Stage 03: Code Administrator Consultation

Grid Code

GC0118:

Mod Title: Modification to the Grid Code to accommodate the recent Distribution Code modification to Engineering Recommendation P28 – *Voltage fluctuations and the connection of disturbing equipment to transmission systems and distribution networks in the United Kingdom.*

Figure CC.6.1.7 (1) — Voltage characteristic for frequent events

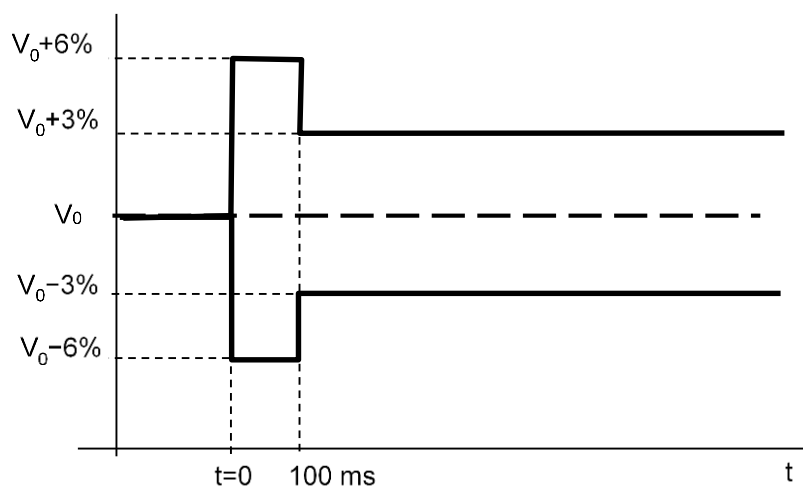
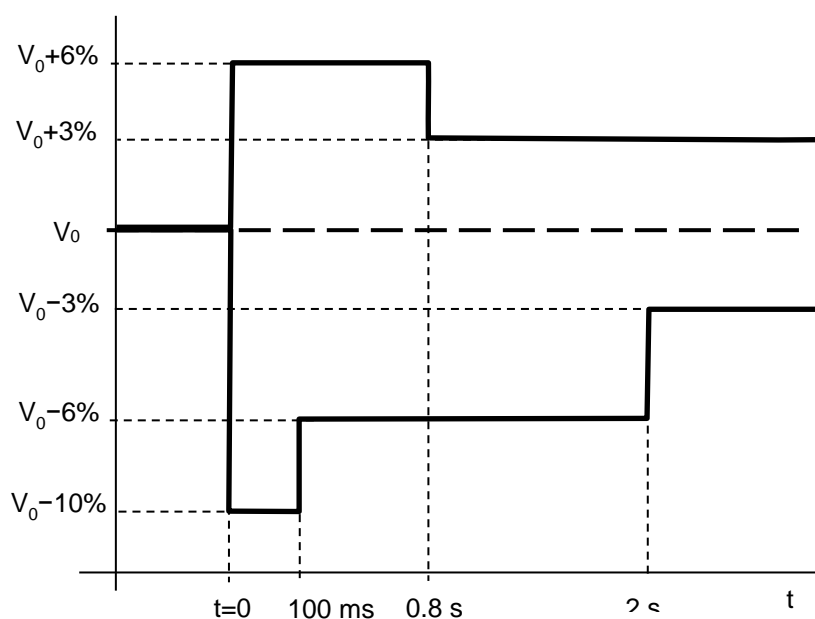
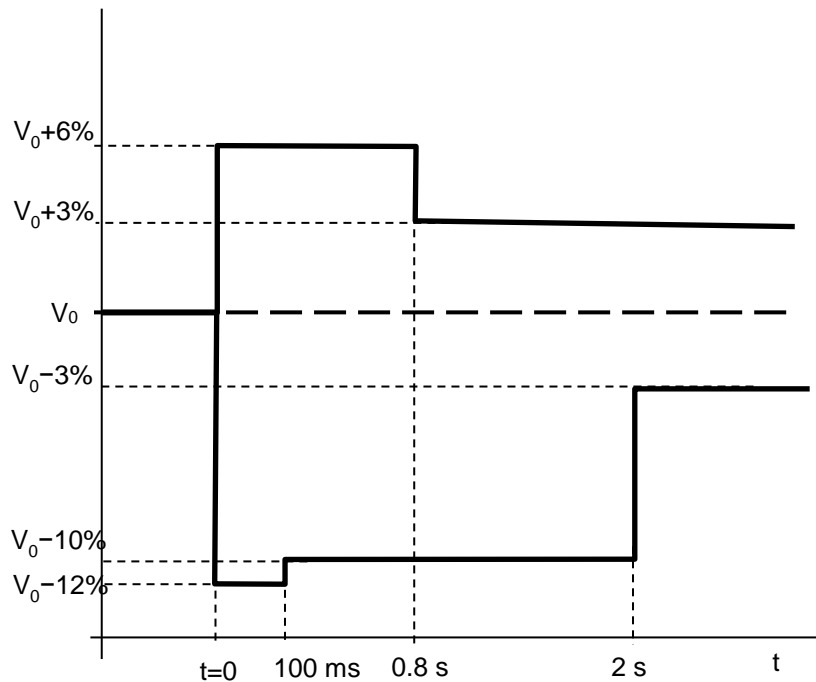
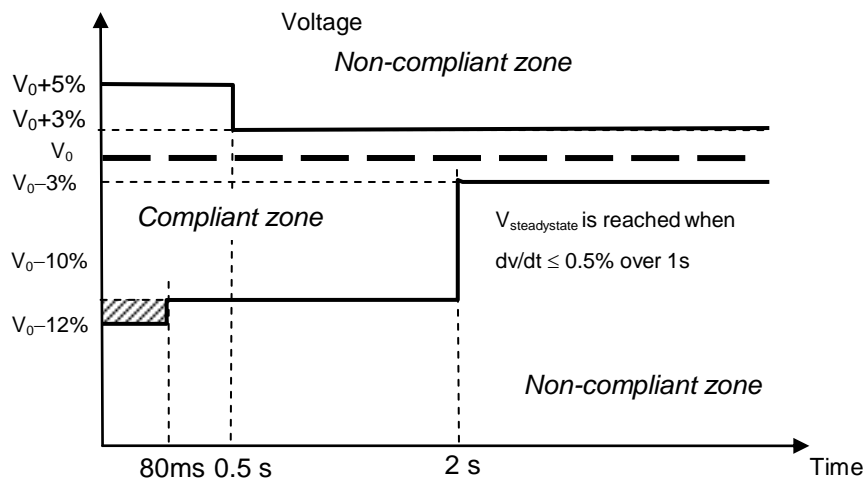
The most significant impact is to the requirements for Rapid Voltage Changes (RVC) in CC.6.1.7 and ECC.6.1.7 of the Grid Code, in particular Tables CC.6.1.7 and ECC.6.1.7. The limits for RVCs proposed in EREC P28 Issue 2 take into account those in the GC0076 modification to the Grid Code. The key differences between the requirements in EREC P28 Issue 2 and those in the Grid Code are as follows, noting that the intention is to align the requirements in the Grid Code with those in EREC P28 Issue 2, so as to provide greater flexibility for customer connections and to be less onerous for customers to comply with and for NGET in terms of operation of the transmission system.

- Allowable voltage changes are expressed as a percentage of nominal voltage (V_n) in P28 Issue 2 as opposed to a percentage of the initial voltage (V_o) in the Grid Code. The intention being to align with the approach taken in National and International Standards.
- For increases in voltage:
 - EREC P28 Issue 2 proposes a limit on the maximum voltage change between two steady state conditions of $\Delta V_{\max} \leq 6\%$ for a maximum duration of 0.8 s from the initiation of a voltage change.
 - The Grid Code has a limit of $\Delta V_{\max} \leq 5\%$ for a maximum duration of 0.5 s.
- For decreases in voltage:

- o EREC P28 Issue 2 proposes a time limit of 100 ms from initiation of a voltage change during which the maximum voltage change permitted. Voltage decreases of 12% for 'very infrequent events' and 10% for 'infrequent events' are proposed.

- o The Grid Code has a time limit of 80 ms from initiation of a voltage change during which the maximum permitted voltage change is -12%.
- For increases and decreases in voltage, EREC P28 Issue 2 permits a greater maximum number of occurrences for Category 3 'very infrequent' events:

The difference between the voltage envelope for Rapid Voltage Changes in Figure CC.6.1.7 of the Grid Code (the black lines denote the existing requirement) and Table 4 of EREC P28 Issue 2 (the red lines denote the proposed requirement) for Very Infrequent RVCs are shown in the above figure. The Distribution Code Review Panel P28 Working Group has proposed limits for RVC in EREC P28 Issue 2 that:

NOTE 1: $\pm 6\%$ is permissible for 100 ms reduced to $\pm 3\%$ thereafter as per Figure CC.6.1.7 (1).
If the profile of repetitive voltage change(s) falls within the envelope given in Figure CC.6.1.7 (1), the assessment of such voltage change(s) shall be undertaken according to the recommendations for assessment of flicker and shall conform to the planning levels provided for flicker.
If any part of the voltage change(s) falls outside the envelope given in Figure CC.6.1.7(1), the assessment of such voltage changes, repetitive or not, shall be done according to the guidance and limits for RVCs.

NOTE 3: -10% is permissible for 100 ms reduced to -6% until 2 s then reduced to -3% thereafter as per Figure CC.6.1.7 (1).

NOTE 4: $+6\%$ is permissible for 0.8 s from the instant the event begins then reduced to $+3\%$ thereafter as per Figure CC.6.1.7 (2).

NOTE 5: -12% is permissible for 100 ms reduced to -10% until 2 s then reduced to -3% thereafter as per Figure CC.6.1.7 (3).

NOTE 6: $+6\%$ is permissible for 0.8 s from the instant the event begins then reduced to $+3\%$ thereafter as per Figure CC.6.1.7 (3).

Figure B.1.2 — $P_{st} = 0.5$ curve for rectangular voltage changes

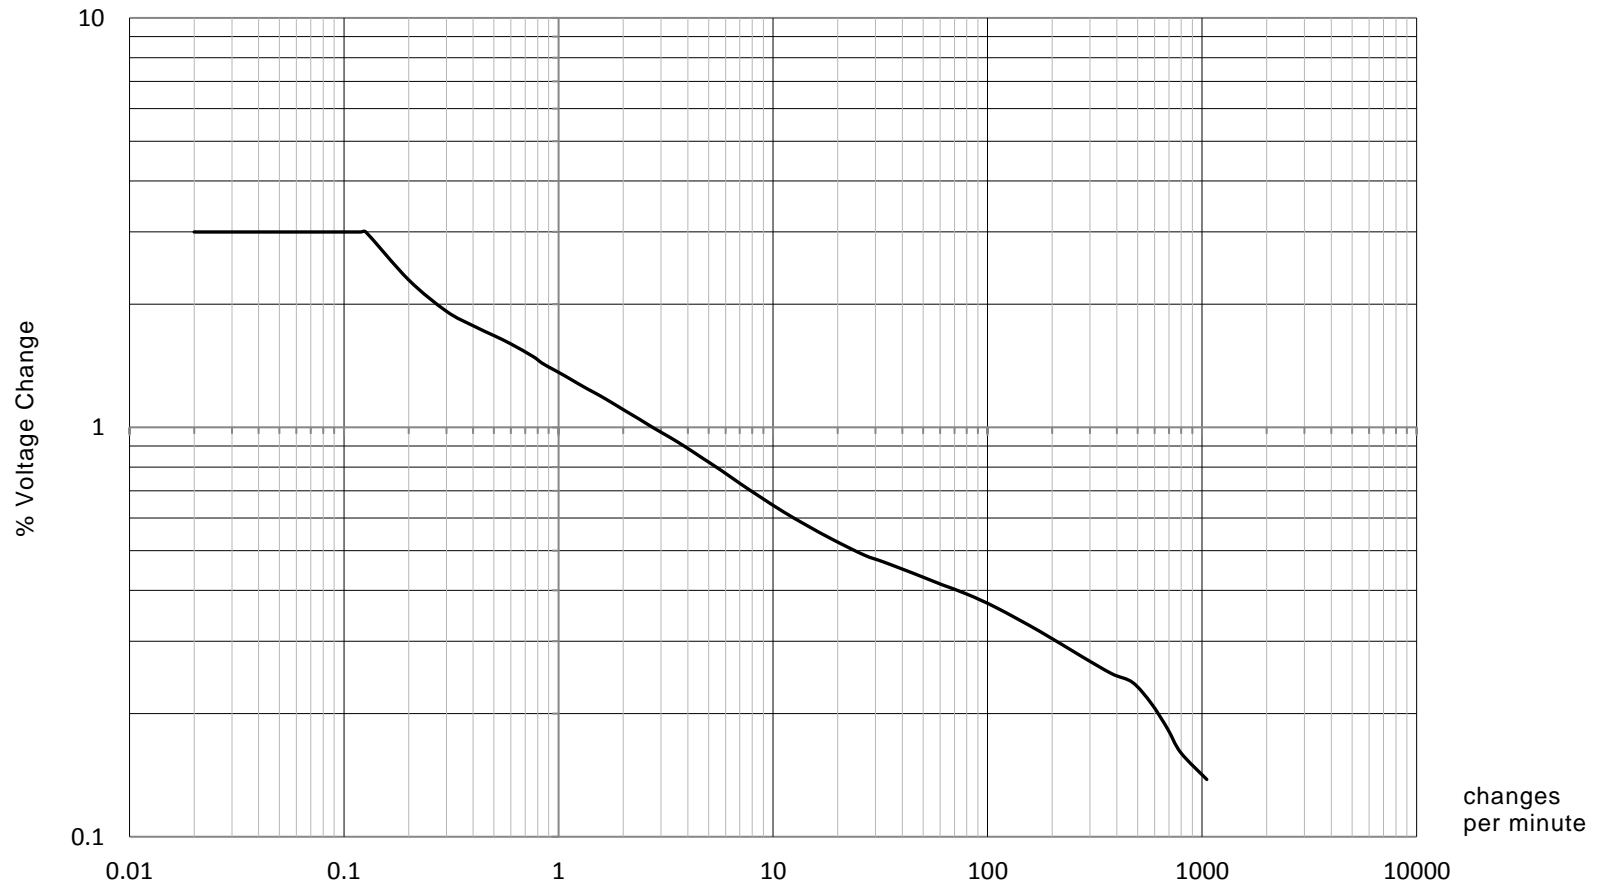
- b) The same respondent also noted there is a reference to current version P28 figure 4 in the SQSS and EREC P28 Issue 2 replaces the original figure 4 with figure B.1.2 and asked for confirmation whether these are the same and whether the SQSS will be corrected?

- i) The Working Group note the acknowledgment in the SQSS that EREC P28 Issue 1 Figure 4 was used in the derivation of Figure 6.1 'Maximum Voltage Step Changes Permitted for Operational Switching'. Figure B.1.2 in EREC P28 Issue 2 is intended to replace Figure 4 in EREC P28 Issue 1 but has been aligned with the current flicker severity curve in Figure A.1 of PD IEC/TR 61000-3-7 – except that the curve has been deliberately capped at a maximum symmetrical step voltage change of 3% once every 475 s. Consequently, the curve in Figure B.1.2 in EREC P28 Issue 2 differs from that in Figure 4 of EREC P28 Issue 1 and Figure 6.1 of the SQSS. The P28 Working Group recommend that Figure 6.1 in the SQSS is reviewed in light of the current flicker severity curve in Figure A.1 of PD IEC/TR 61000-3-7 and the aligned Figure B.1.2 in EREC P28 Issue 2.

Figure 5 — Voltage characteristic for frequent events (Category 1)

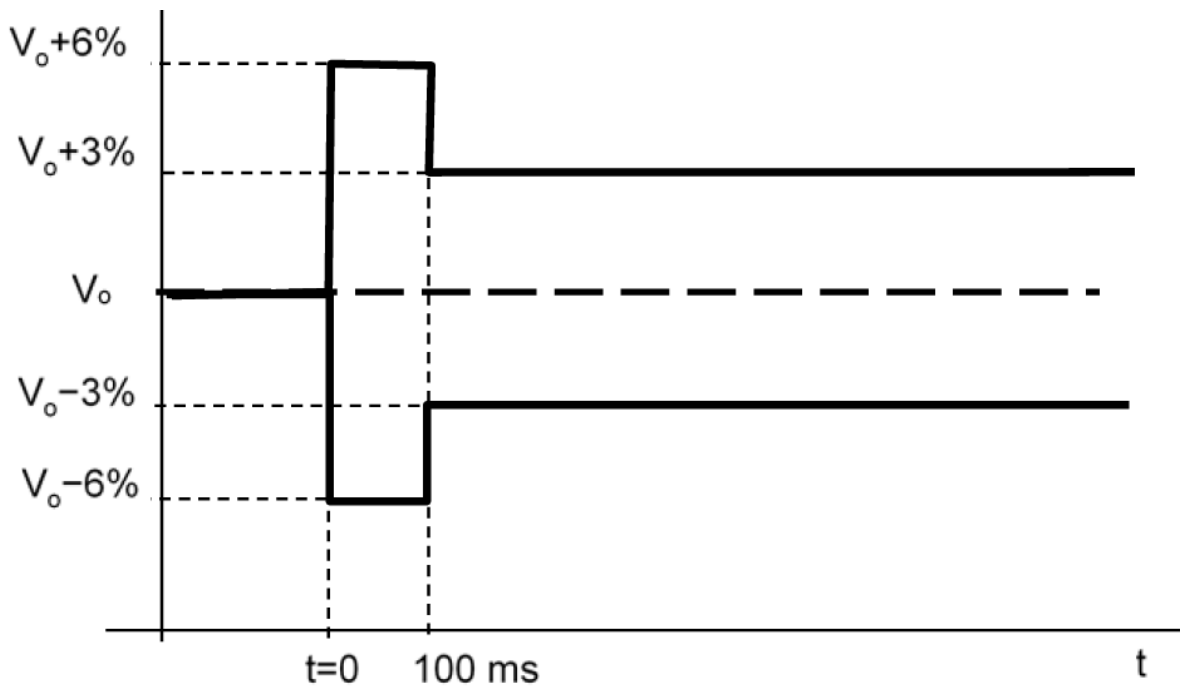
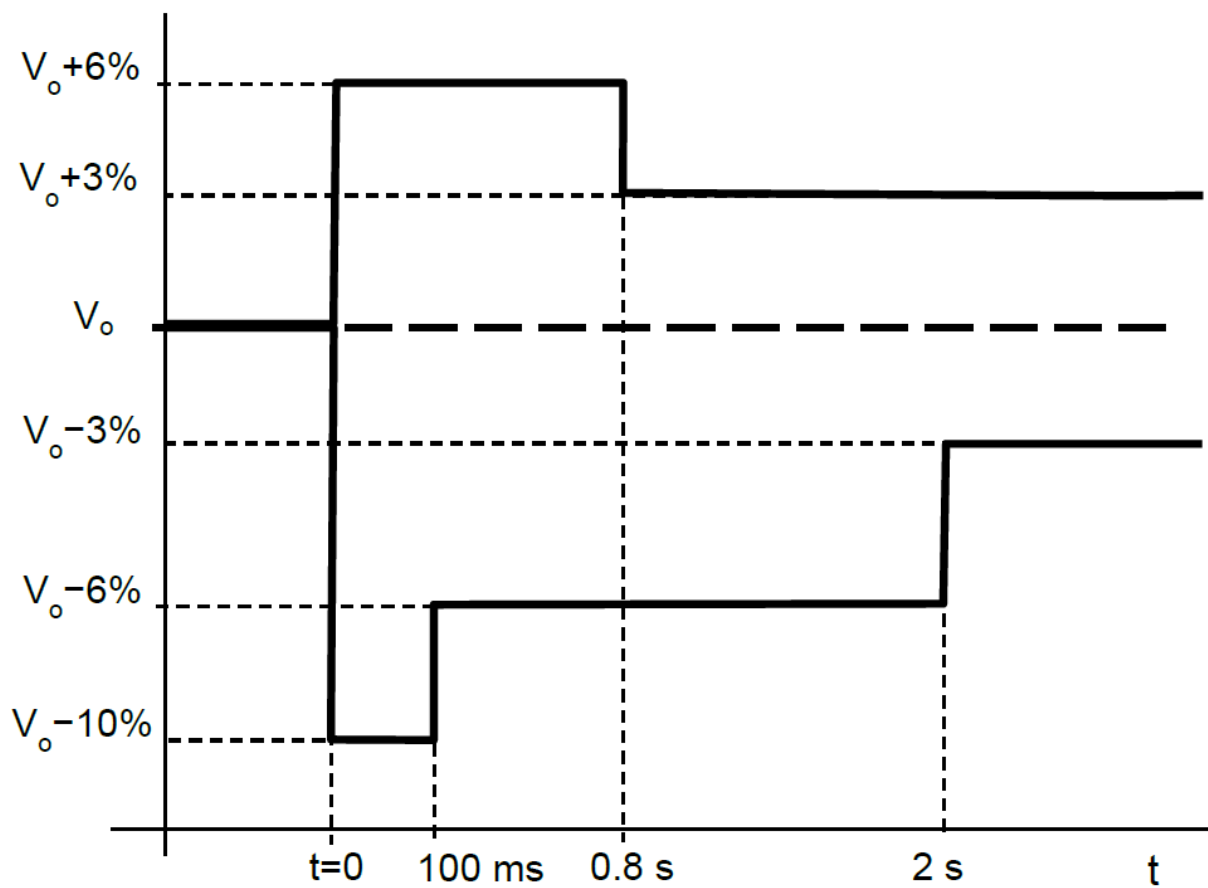
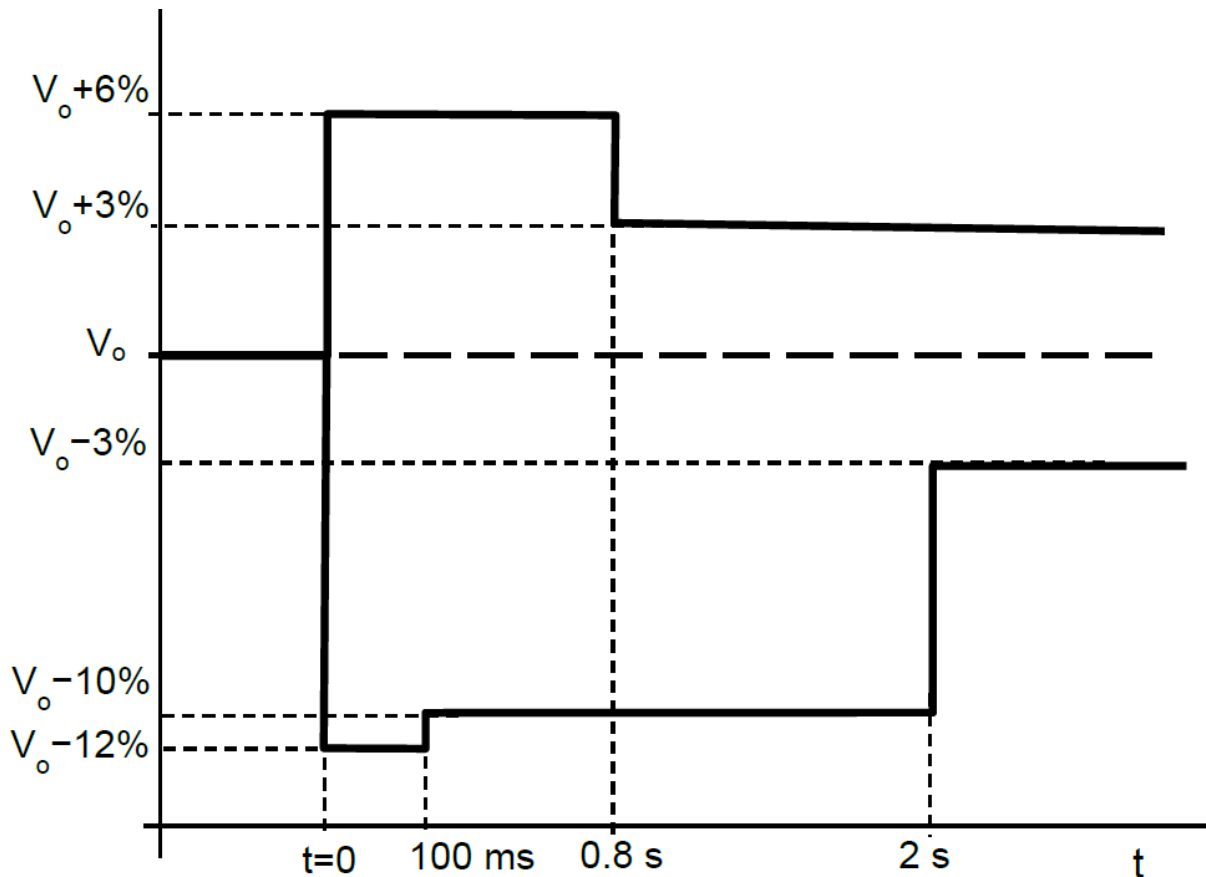
- 5.6 However, two of the respondents provided extensive comments in relation to the proposed requirements and planning levels for RVCs as provided in Figure 5, Figure

i) In response, the Working Group do not believe the requirements in EREC P28 Issue 2 are more onerous than Category 2 of Grid Code CC.6.1.7. The time and voltage magnitude limits for Category 3 RVCs shown in Figure CC.6.1.7 of the Grid Code when compared with Figure 7 of EREC P28 Issue 2 confirm that both the time and voltage limits in EREC P28 Issue 2 for Category 3 very infrequent events (not more than 4 RVCs in 1 day providing less frequent than once every 3 calendar months) are less onerous than those for Category 3 RVCs in the Grid Code.

4.2.11 The minimum interval between frequent events fitting within the envelope in Figure 5 is determined by conformance to flicker severity (P_{st}) limits in EREC P28 Issue 2.

4.2.12 Up to 4 RVC events per calendar month are permitted for voltage fluctuations fitting within the envelope in Figure 6.

- EREC P28 Issue 2 introduces an intermediate category of RVC (Category 2) for 'infrequent events', where up to a maximum of 4 RVCs in one day are permitted not more frequent than 4 times per month providing the $\Delta V_{\max} \leq -10\%$ for ≤ 100 ms then reducing to $\leq 6\%$ for up to 2 s after initiation of the event (see Figure 6).
